City of Sandy

Planning Commission Meeting
Meeting Location: Hybrid - 39250
Pioneer Blvd. and Zoom
Meeting Date: Monday, January
30, 2023
Meeting Time: 6:30 PM

Meeting Date: January 30, 2023
From Shelley Denison, Associate Planner
SUBJECT: 22-037 DR/VAR - Johnson RV Canopy Cover

**PLANNING COMMISSION STAFF REPORT
TYPE III LAND USE PROPOSAL**

JOHNSON RV
RV STAGING, BUILDING AND UTILITY PLANS
EXISTING CONDITIONS PLAN
SE INDUSTRIAL WAY AND SE 362ND, SANDY, OR 97055

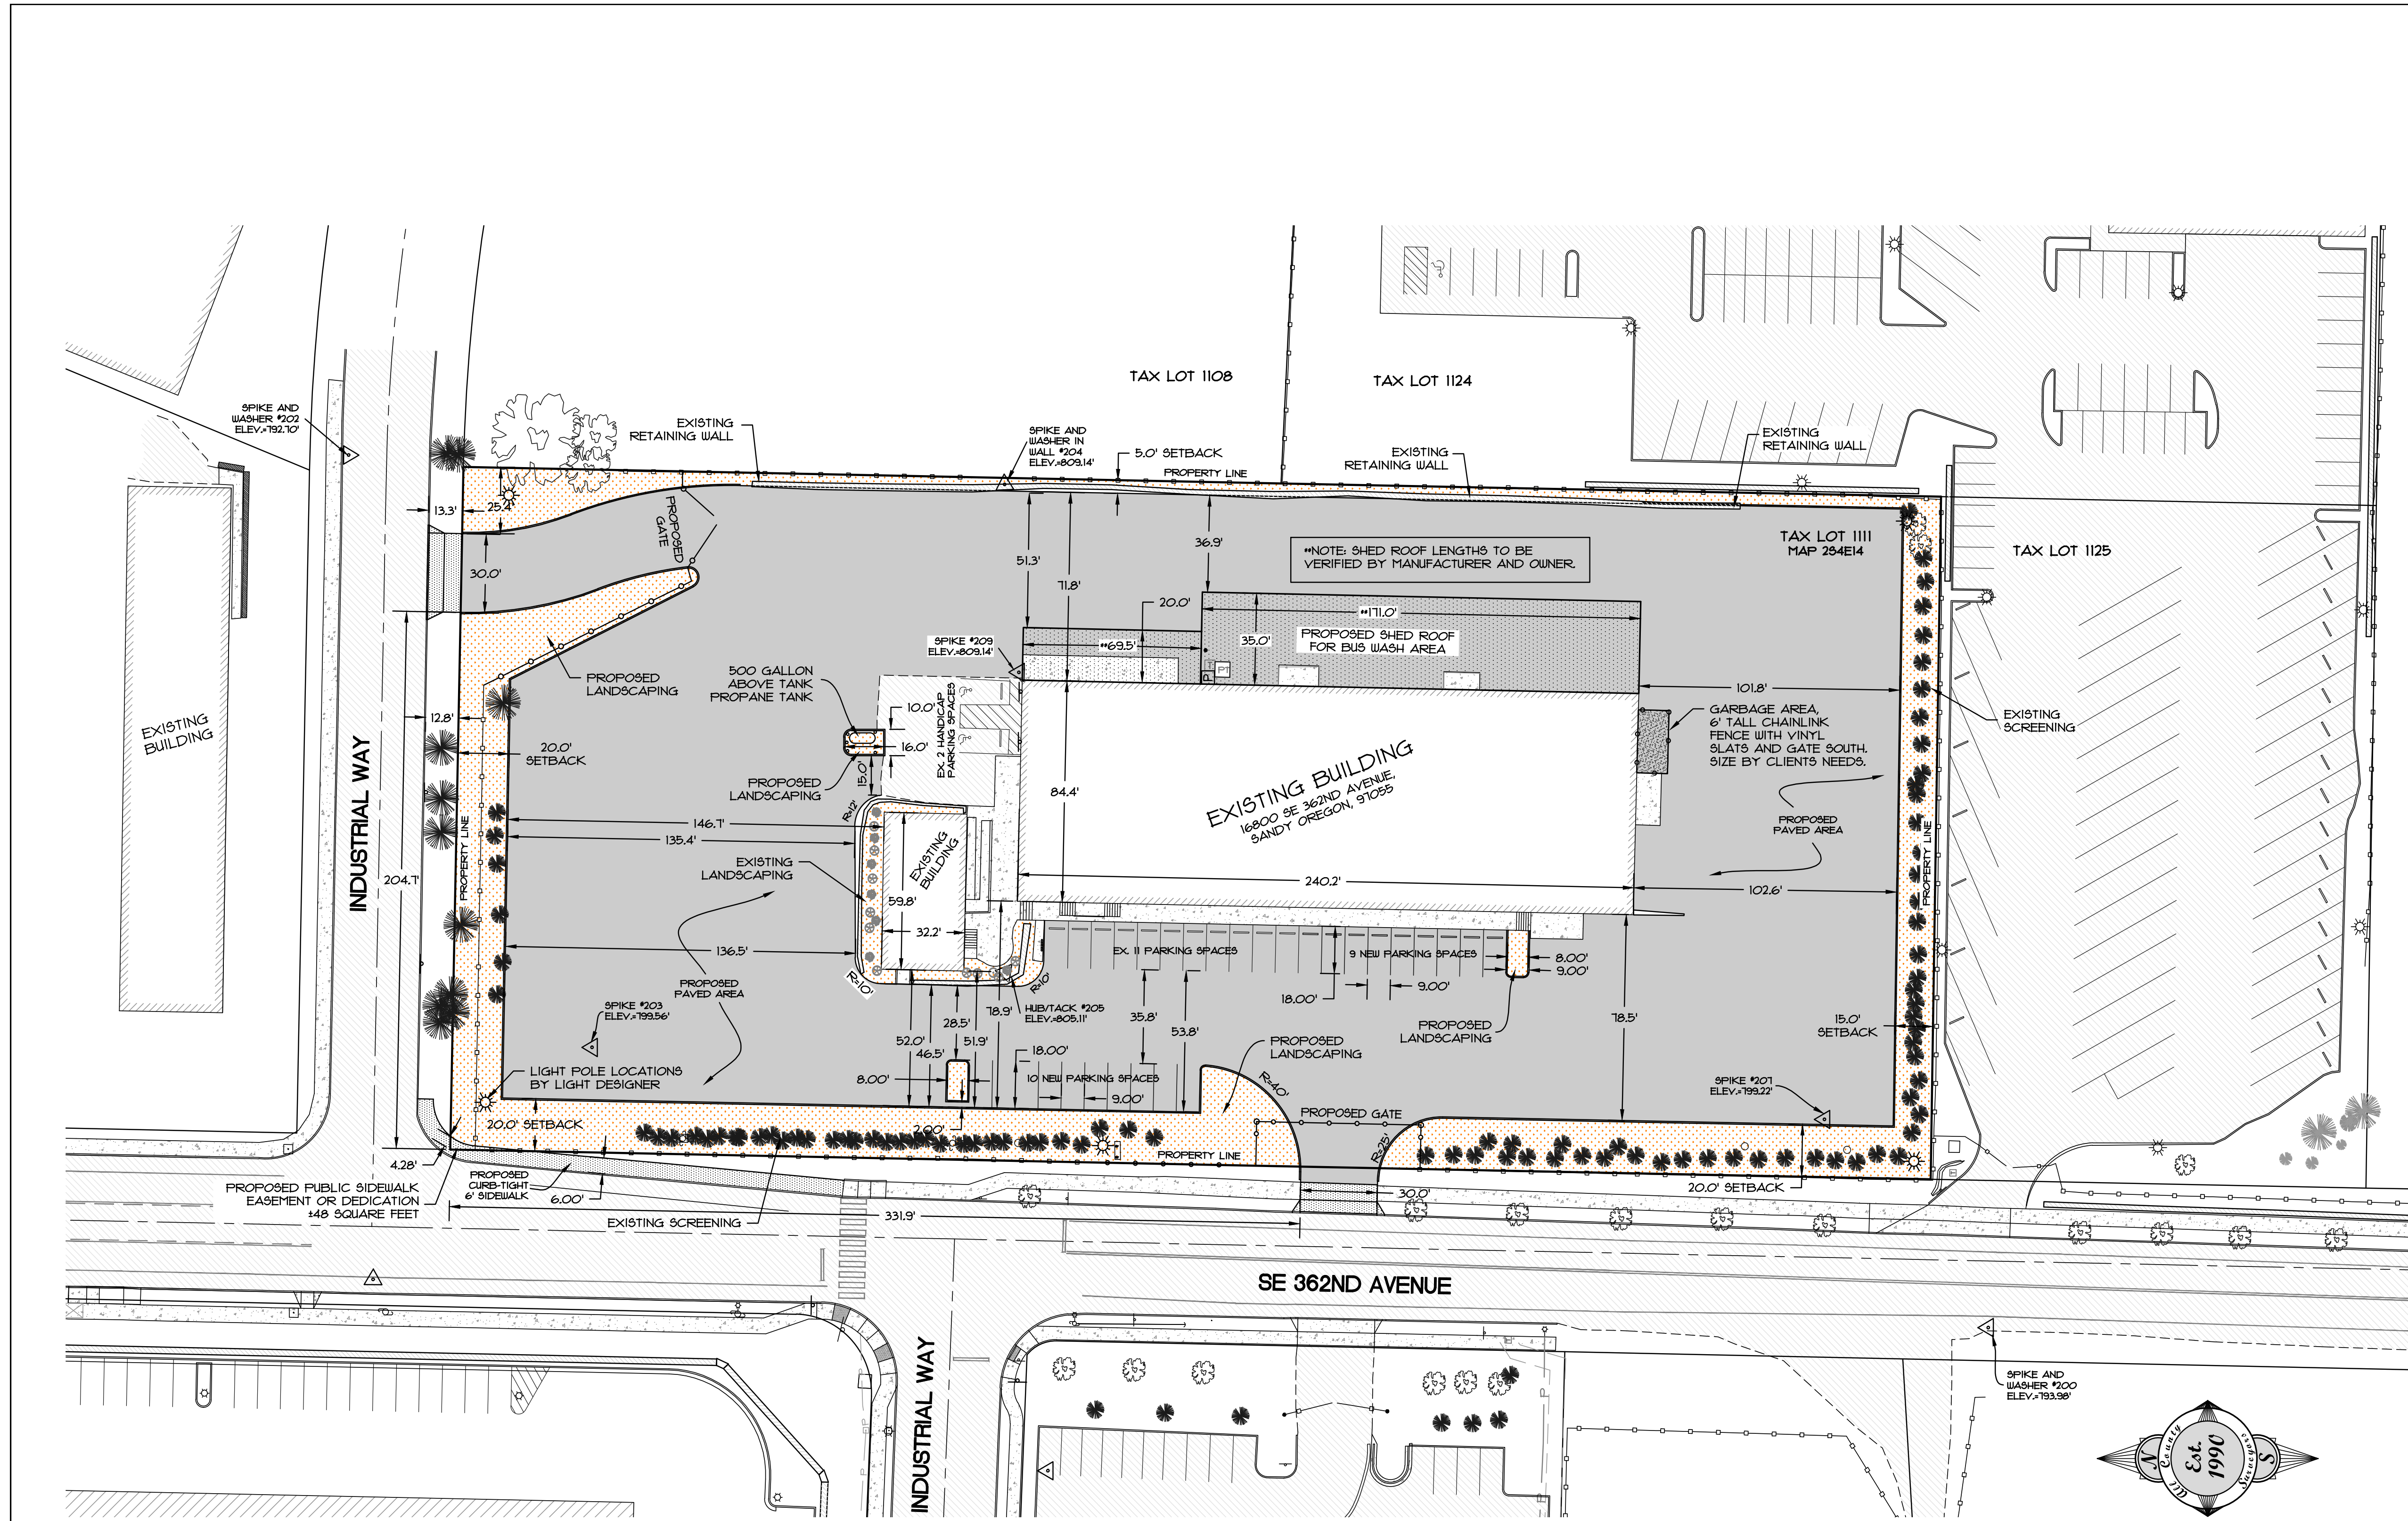
34. Sheet C2 of Exhibit D shows an existing six (6) foot tall chain link fence with barbed wire surrounding the property. A portion of this fence will be relocated to accommodate the new entrances on 362nd Drive and Industrial Way. Per Section 17.74.40(E), **the relocated fences shall be six (6) feet in height with the barbed wire extending no more than two (2) feet above the top of the fence.**

JOHNSON RV
 RV STAGING, BUILDING AND UTILITY PLANS
 PROPOSED SITE PLAN
 SE INDUSTRIAL WAY AND SE 362ND, SANDY, OR 97055

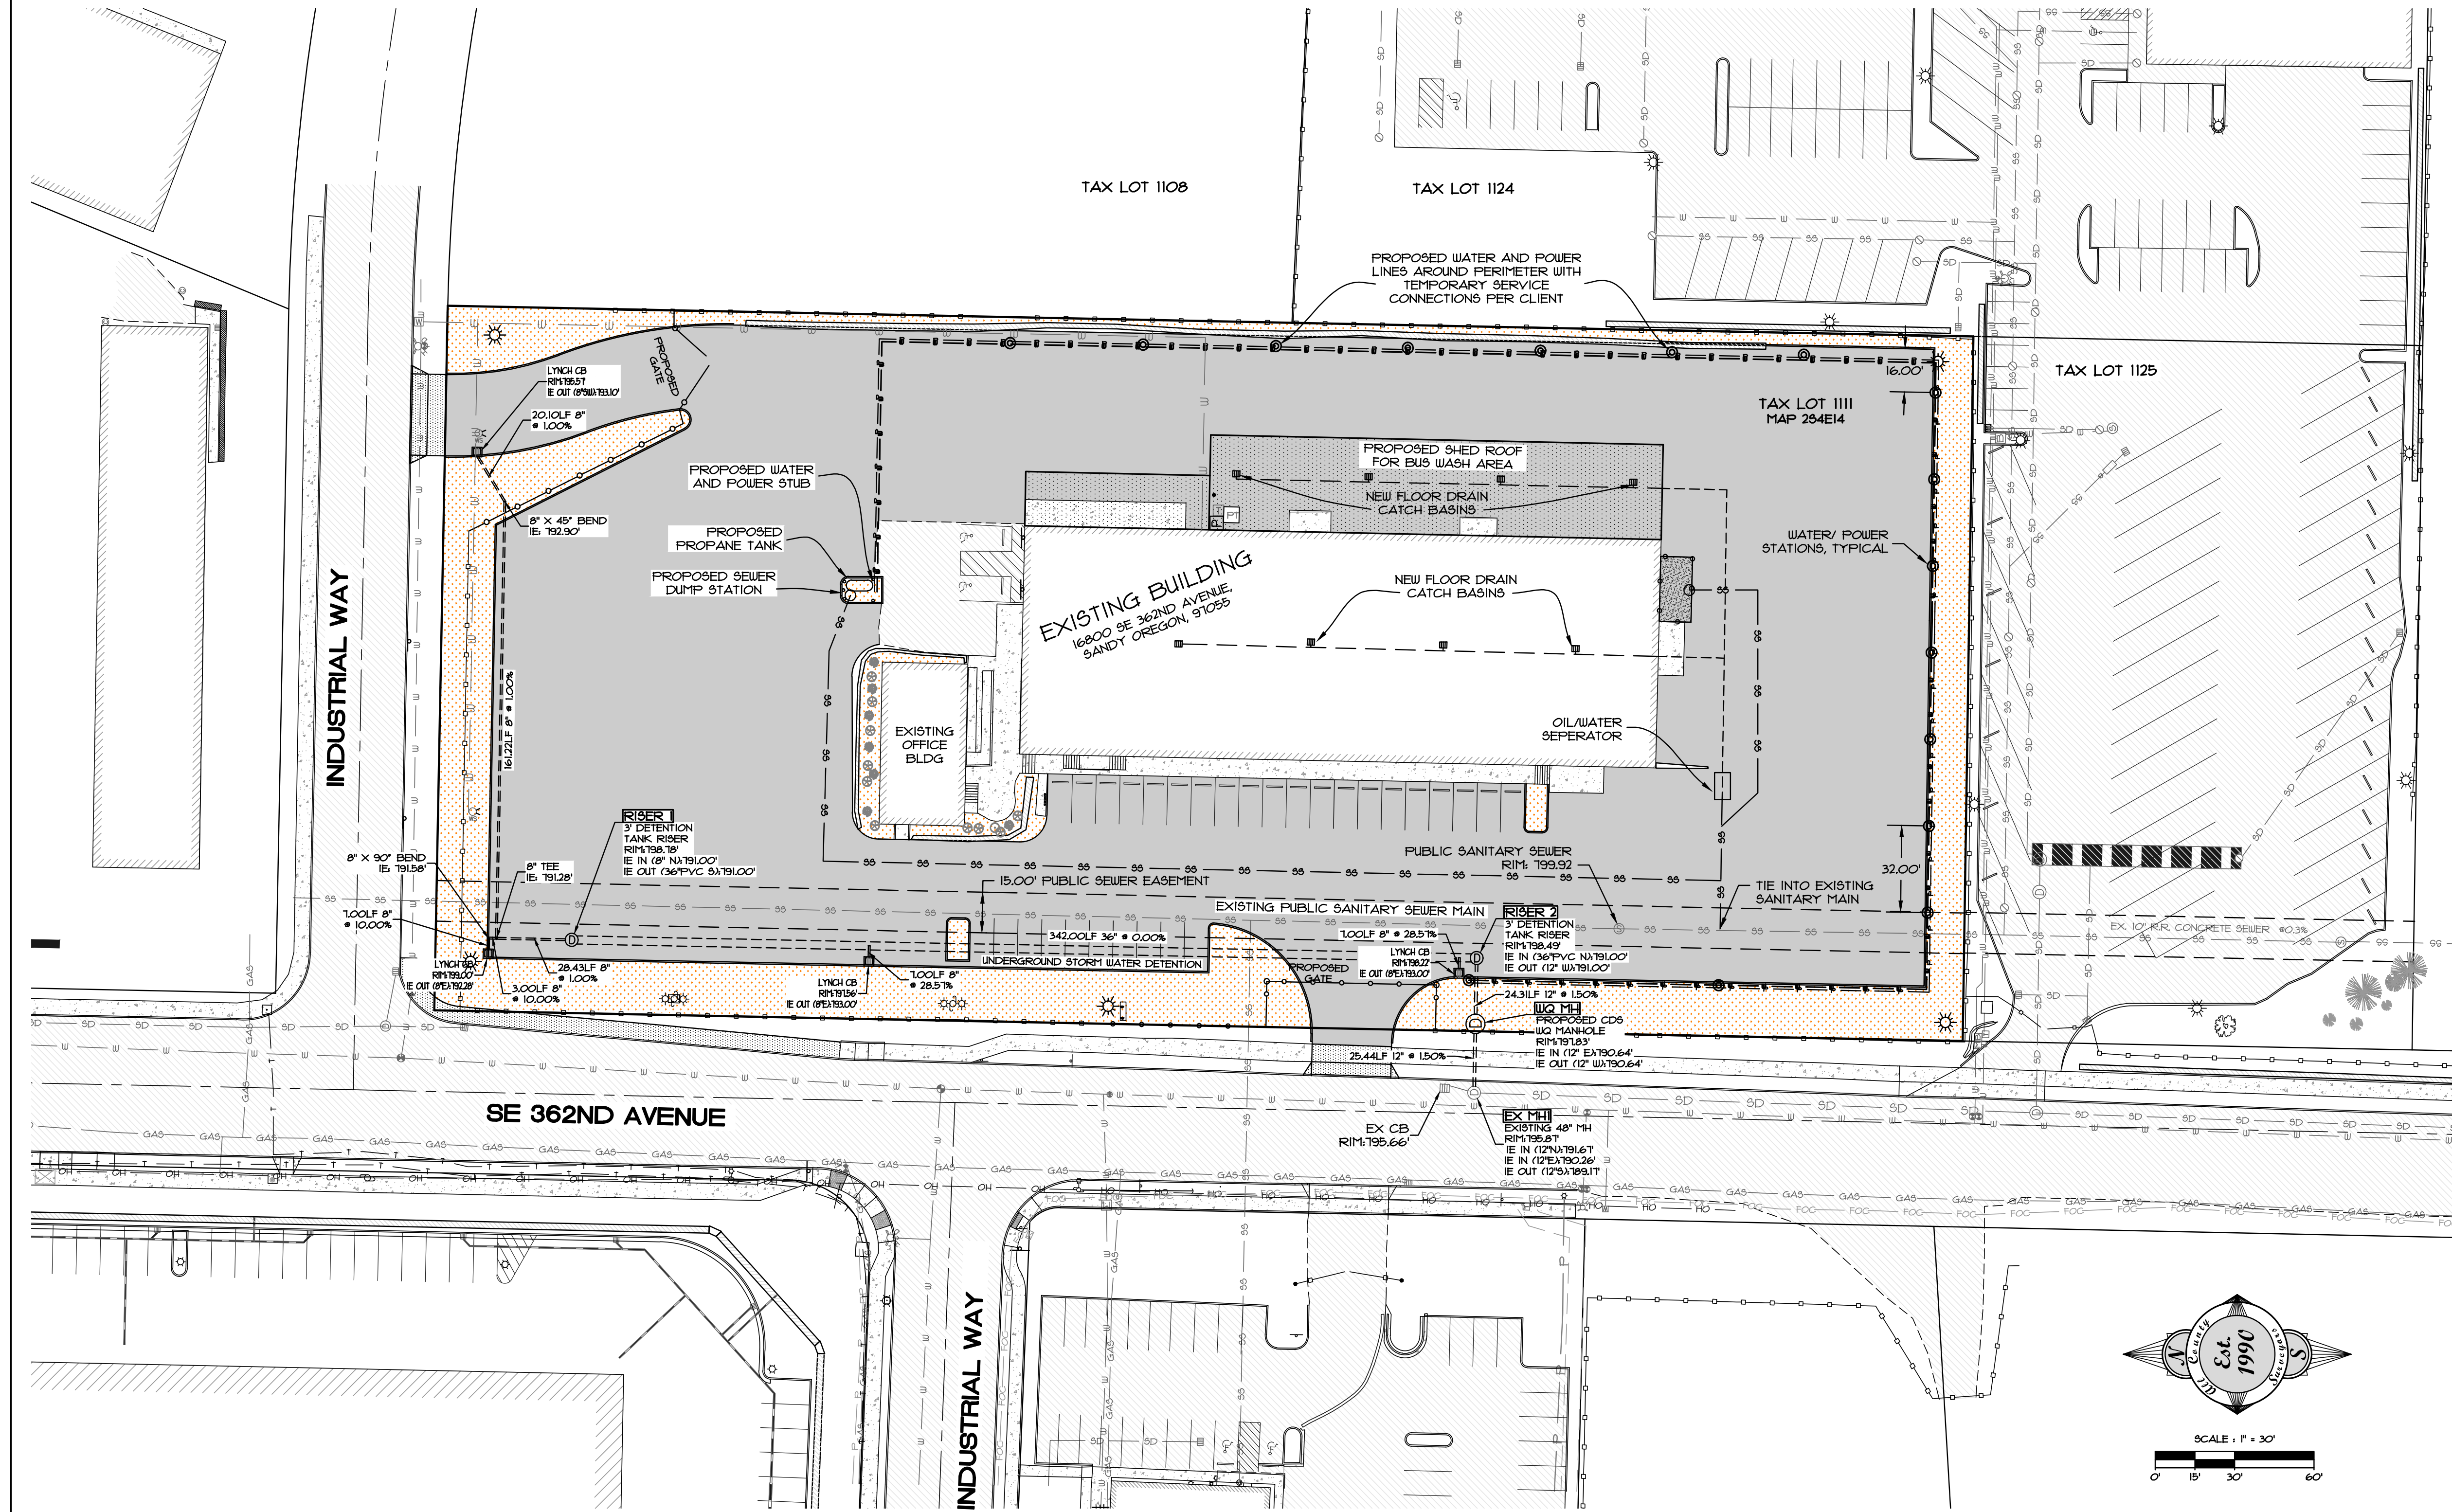
33. Sheet C3 of Exhibit D shows a proposed fenced garbage enclosure in what would be considered the side yard of the property. This fence is proposed to be six (6) feet in height, complying with this standard.

70. As required by Section 17.98.160, bicycle spaces must be 2.5 feet wide and six (6) feet deep. It is unclear from the submitted site plan if the existing bicycle parking spaces meet this requirement. Additionally, as explained in the analysis for Section 17.98.120 of this staff report, a planter will be required in the current location of the site's bicycle parking. **The**

applicant shall submit an updated site plan showing a new location for bicycle parking in compliance with the requirements found in Section 17.98.160.

A3.01

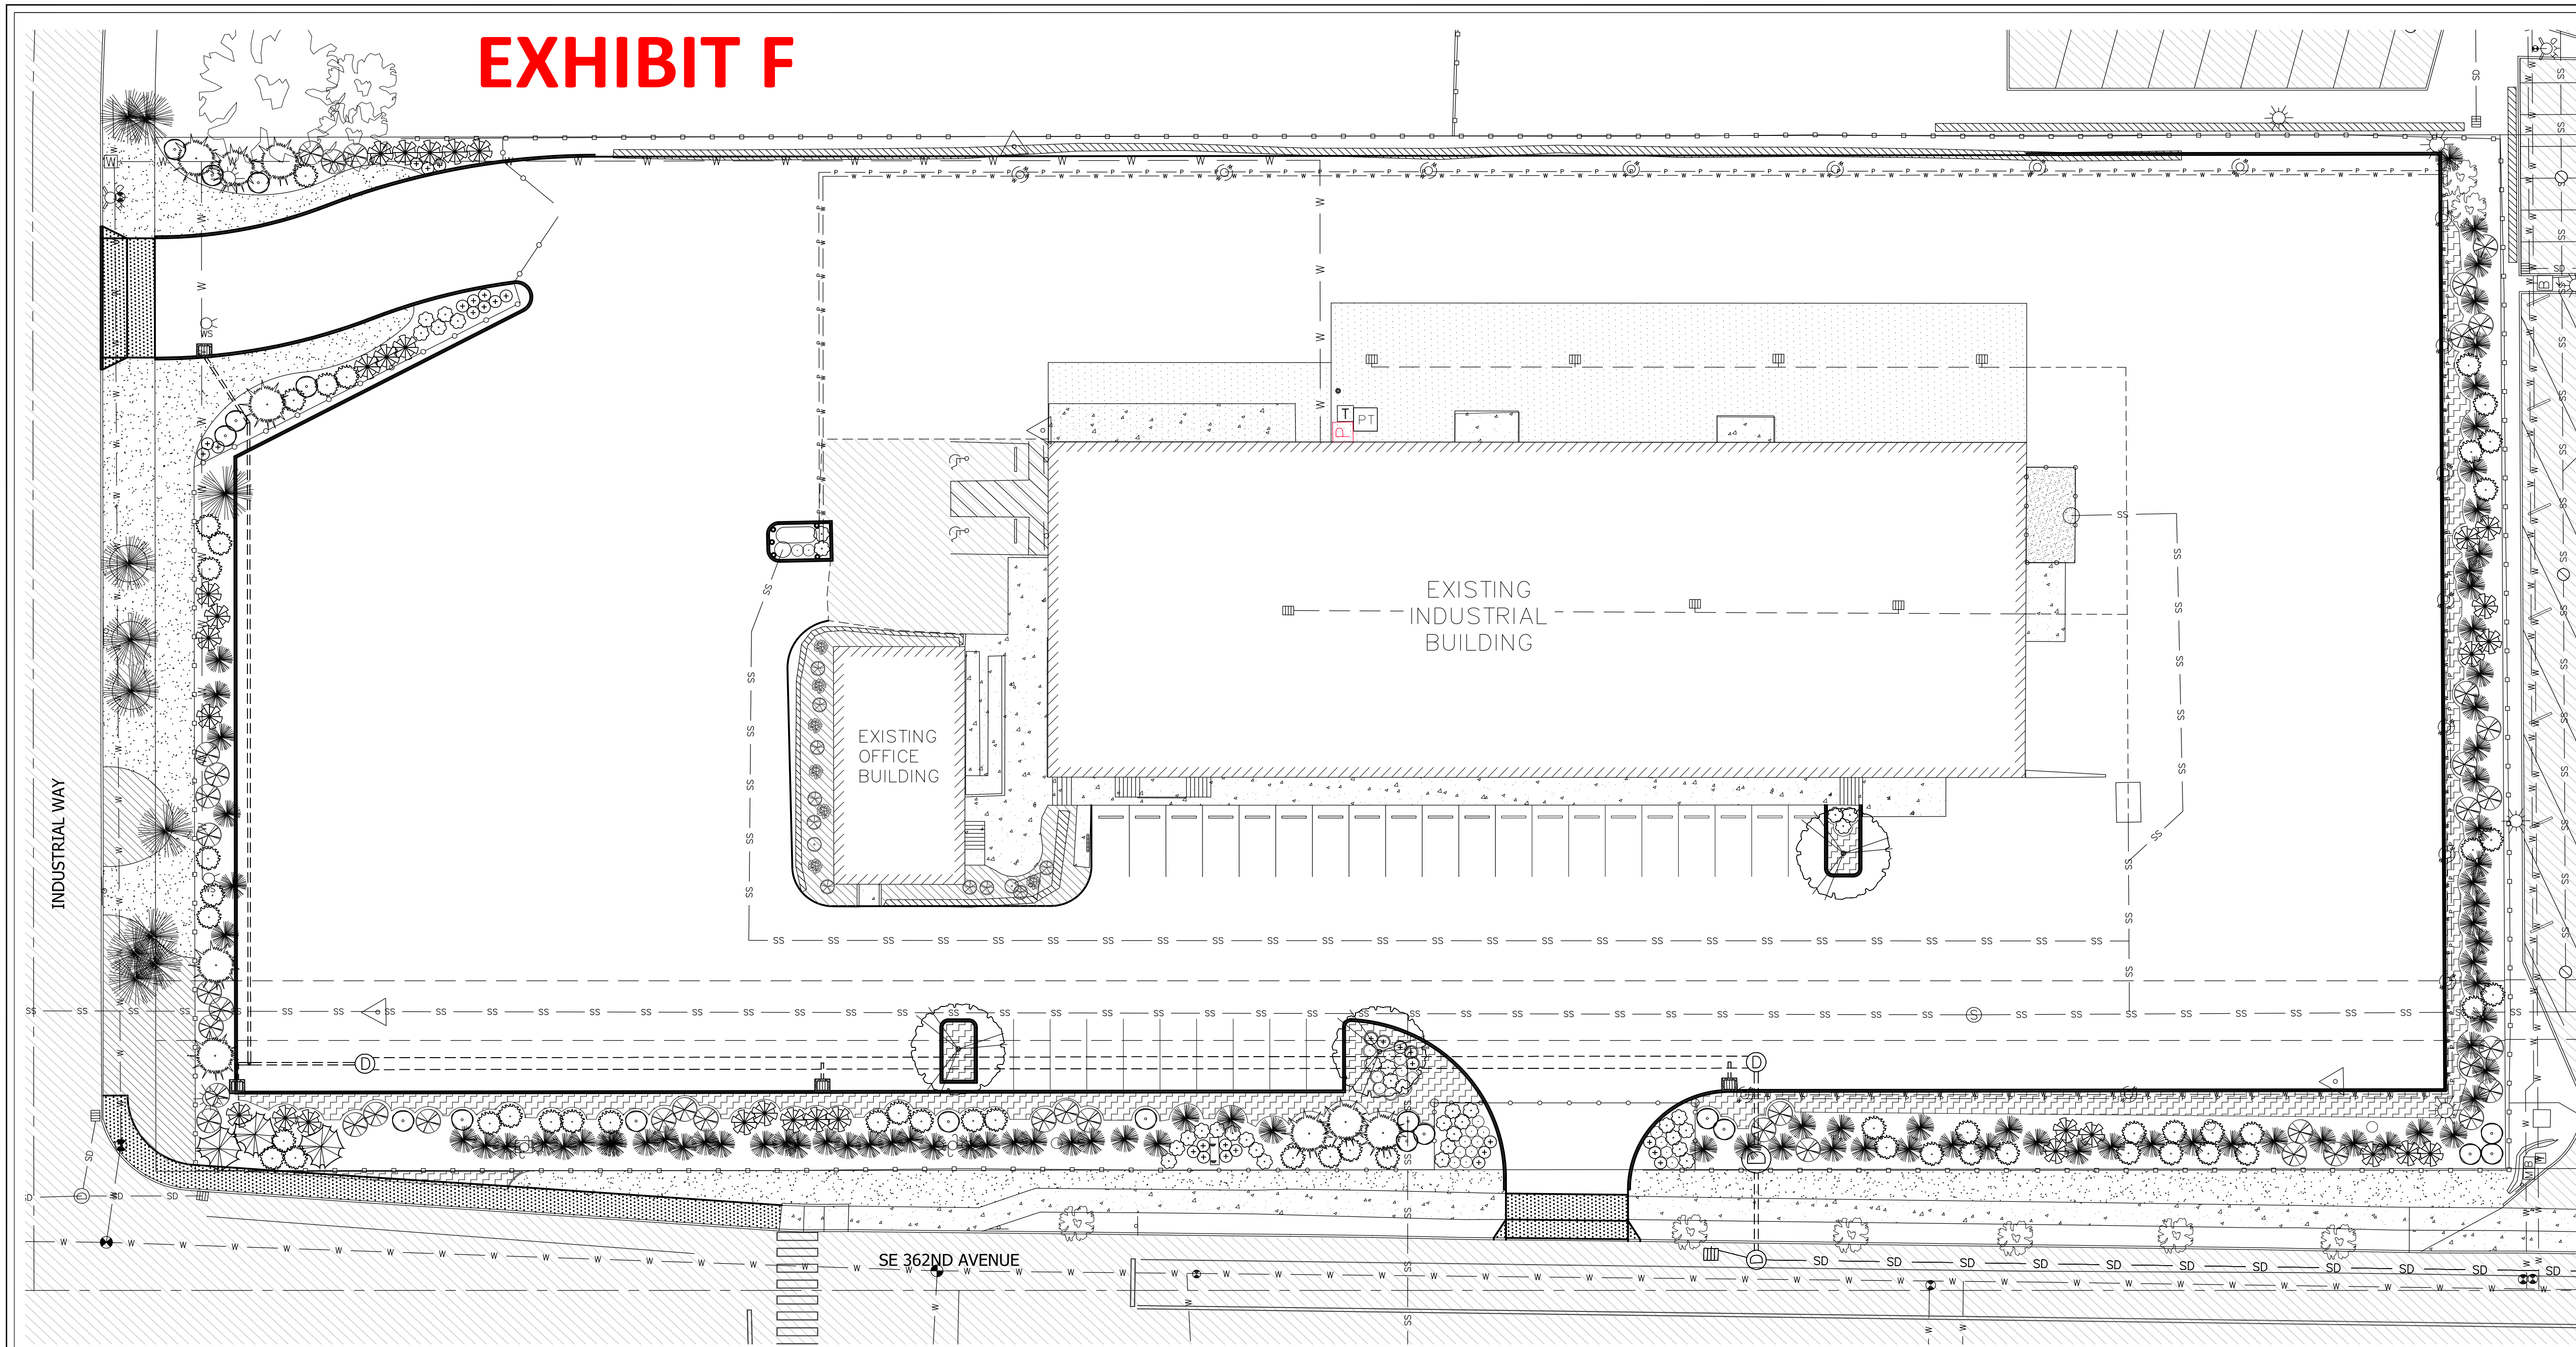
13. The maximum allowable structure height in the I-2 zone is 45 feet. According to the architectural elevation plans (Exhibit E), the awning is proposed to be 22 feet and eight (8) inches in height.

36. The applicant has requested a variance to the required roof pitch standard found in Section 17.90.130(D). While the Code standard is 3:12, the applicant proposes a 2:12 roof pitch. The applicant's reasoning for this request is that the existing structure has a 2:12 roof pitch and allowing the awning to match would provide architectural consistency.
